January 4, 2022

Re: Comments on I-5 Rose Quarter Supplemental Environmental Assessment

Traffic volume documentation: Typical Study versus I5-RQ Traffic Analysis Supplemental Technical Report*

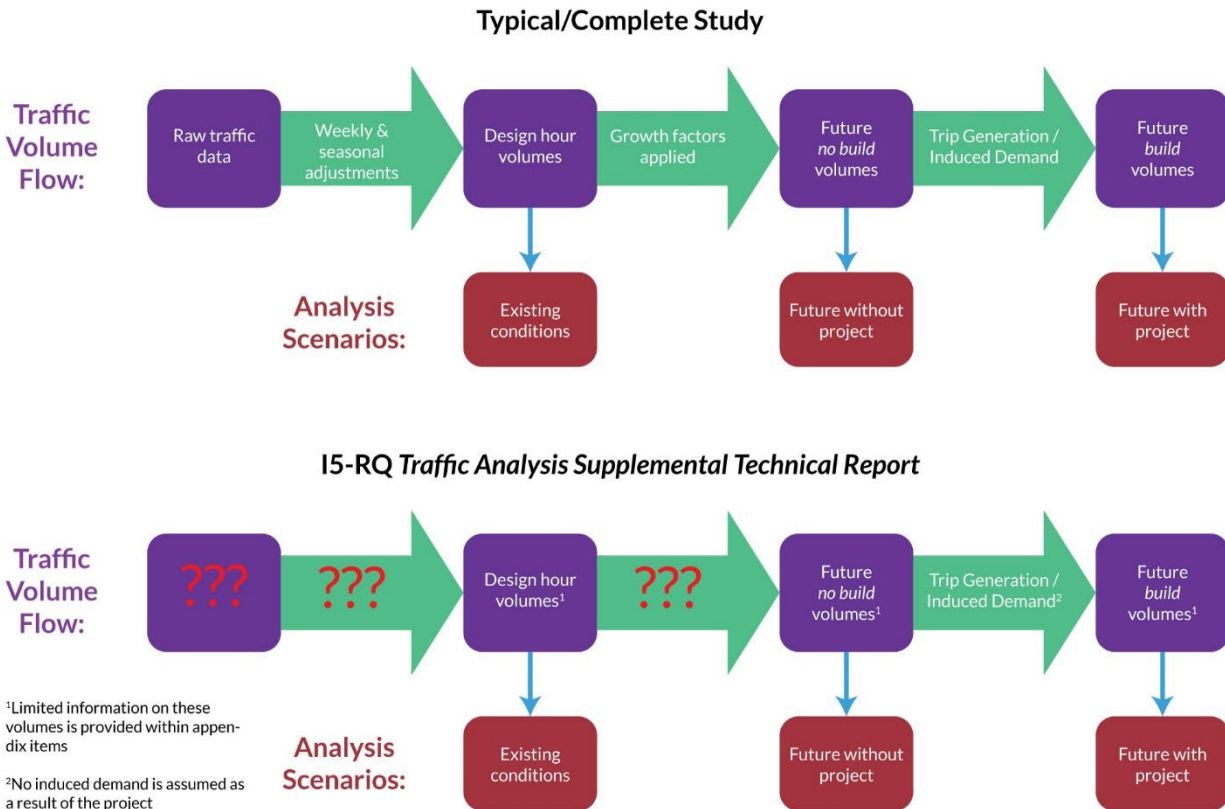
Unfortunately, not only does the document fail to disclose all assumptions and calculations at each step, but *almost no information is provided whatsoever regarding volumes and assumptions*. Indeed, there are no figures nor are any volume data provided within the body of the report. Volumes can be found for some scenarios within modeling outputs provided in the appendix, but this is of limited utility. Based upon the information provided, there is no way to check any calculations, claims, or assumptions regarding volumes, despite the APM’s clear and repeated statements on the importance of documentation and repeatability.

Figure 1 illustrates the extent of the missing and/or ill-documented traffic volume information within the TASTR. A well-prepared study will include documentation of raw volumes, volumes for all analysis scenarios, and exhaustive information of the calculations and assumptions leading from one stage of the process to the next, as shown in the figure. By contrast, the TASTR includes missing data and calculations at many steps and unclear or incomplete information at all others.
